REMARKS

AMENDMENTS TO THE DRAWINGS

Dong-Ho LEE
 STACK PACKAGE MADE OF CHIP SCALE PACKAGES
 Attorney Docket No. 9903-074/Application No. 10/750,979

FIG. 3

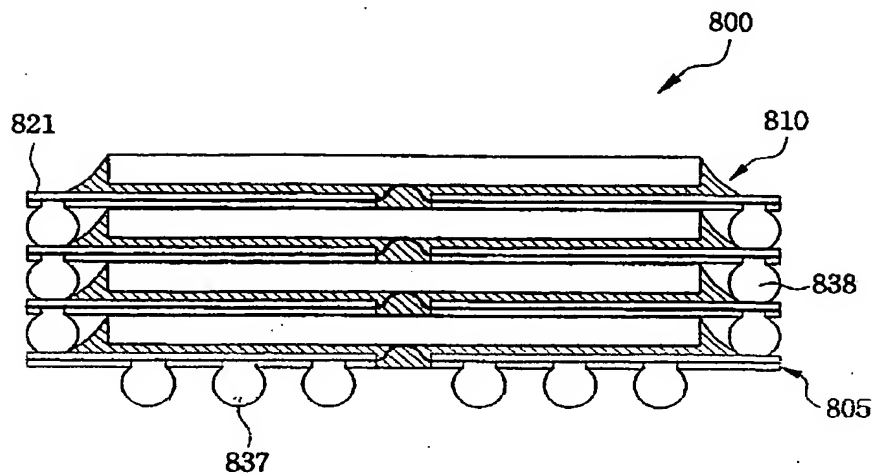
The drawings are objected to as failing to comply with 37 CFR 1.84(p)(5) because they include the following reference characters not mentioned in the description: 821 and 838 of FIG. 3, 151-152, 167, 171, 175, 183 of FIG. 4.

The specification has been amended to properly identify the reference characters in FIGS. 3 and 4.
